Vancouver Apartments

Structural Checksheet/Plan Review Response

Re: Vancouver Apartments – 3724 N. Vancouver Avenue
Permit # 13-137435-000-00-CO
Second Checksheet

13 SA.0 FLOOR FRAMING DETAIL AT DECK/PLANTER 1" = 1'-0"

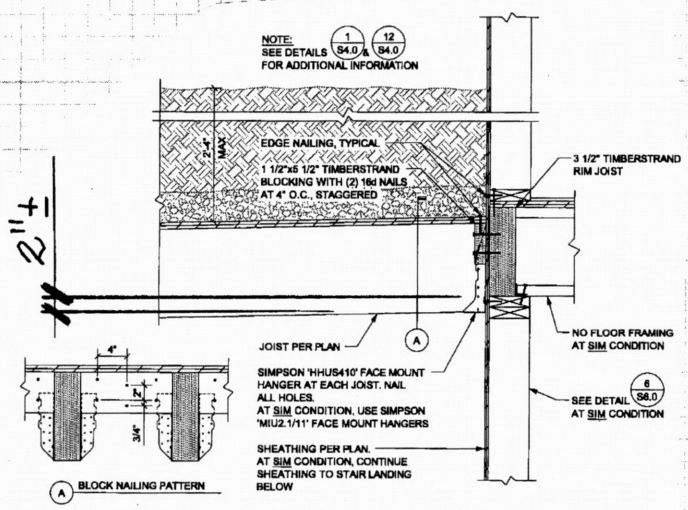
<u>Item</u>	<u>Reference</u>	<u>Response</u>
6	Sheet S1.2 & Detail 13/S4.0	The joist hanger located along grid "I" and detailed in detail 13/S4.0 of the design drawings is a Simpson 'HHUS410". Each hanger's bottom is down some 2" ± from the top of the double top plate. See attached calculations to the adequate capacity of the hanger in lieu of these 2 inches and of the wall stud's capacity.

□ HANGER CAPACITY (PER DESIGN DETAIL 13/SA.0)

- SIMPSON 'HHUSA10'

□ MAX APPLIED LOAD = 3.01 K
 (F-3 OF ORIG. CALCULATIONS)

□ FULL CAPACITY OF HHUSA10, SNOW, = 6.385K w/c

30 NAILS TO HDR + 10 NAILS THRU JOIST TO HDR. - 9" TALL HANGER

→ ADJUSTED CAPACITY $\approx \frac{9"-2"}{9"} \times \text{FULL} \approx 77\% \text{ FULL}$

$\approx \left(\frac{30-4}{30} + \frac{10-4}{10} \right) \left(\frac{1}{2} \right) \times \text{FULL} \approx 73\% \text{ FULL}$

ASSUME 50% FULL = 3.19K \geq MAX LOAD

∴ HANGER ACCEPTABLE
